AMENDMENT/ADDENDUM No. 2

Solicitation Number: 1920-61VS

Description: North Myrtle Beach Middle School MAU & Duct Replacement

Typical MAUs-1, 2 & 3.

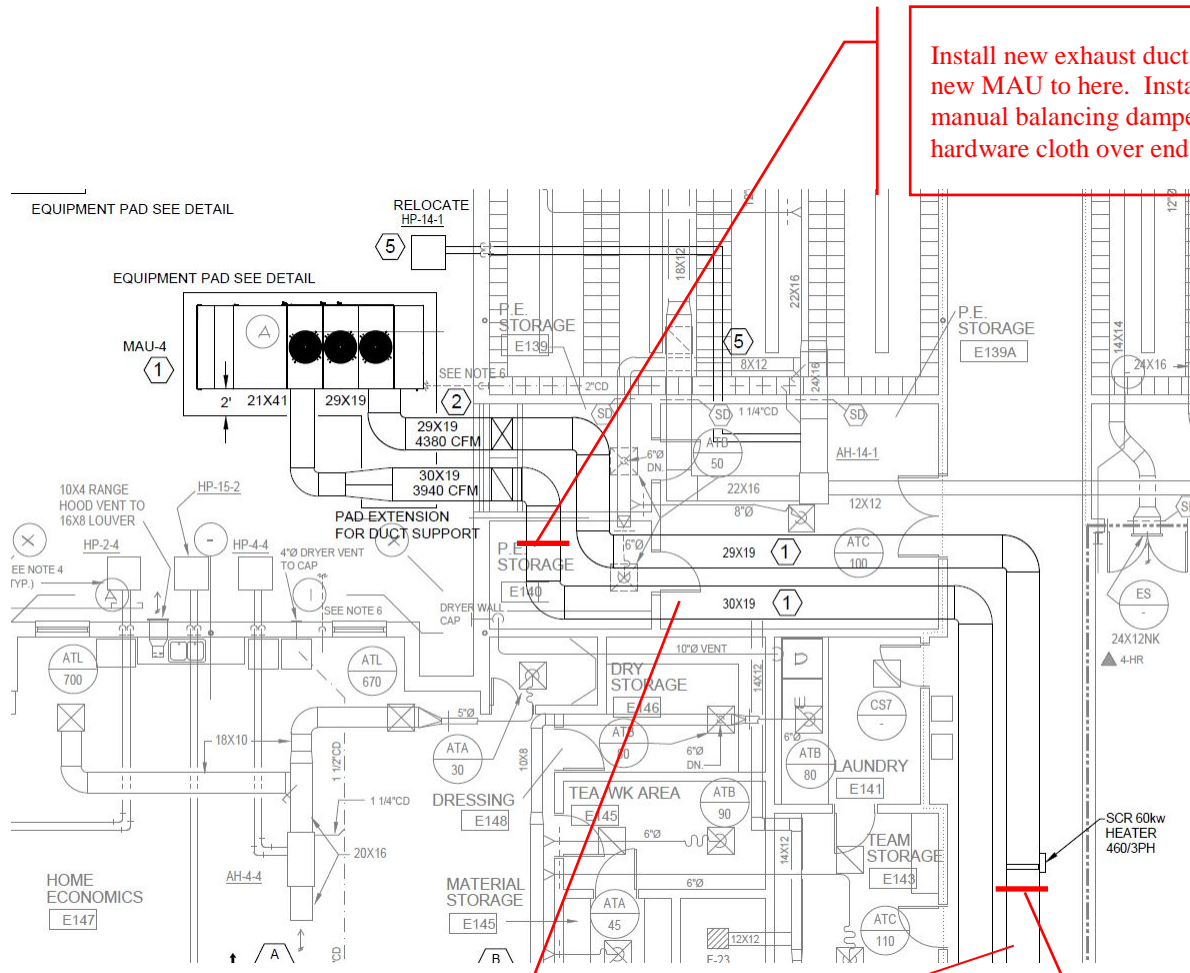
Item # 1 Delete the new supply and exhaust ductwork to and from each new MAU as shown on the Drawings M1, M2 & M3 to the extent shown on the sketches below and as described herein. Existing Outside Air supply fiberglass ductboard as shown on drawings MD1, MD2, MD3 and MD4 to remain "as-installed." Rebalance OA quantities to the duct connection on the existing split system heat pumps serving classrooms and other HVAC zones in the school to the new quantities shown on drawings M1 through M4. Balance the exhaust air quantity being exhausted from the ceiling plenum by adjusting the MAU exhaust fan speed. All other Work required in the Contract Documents to remain as described.

Install new exhaust duct from new MAU to here. Install a manual balancing damper and hardware cloth over end of duct.

Install new OA supply duct from new MAU to here. Transition duct and connect to existing fiberglass ductboard splitter damper.

New supply and exhaust duct, duct accessories and air distribution devices beyond points indicates is deleted from the scope of work.

Install new exhaust duct from new MAU to here. Install a manual balancing damper and hardware cloth over end of duct.

New supply and exhaust duct, duct accessories and air distribution devices beyond duct points indicates is deleted from the scope of work.

Install new OA supply duct from new MAU to here. Transition duct as required and connect to existing fiberglass ductboard.
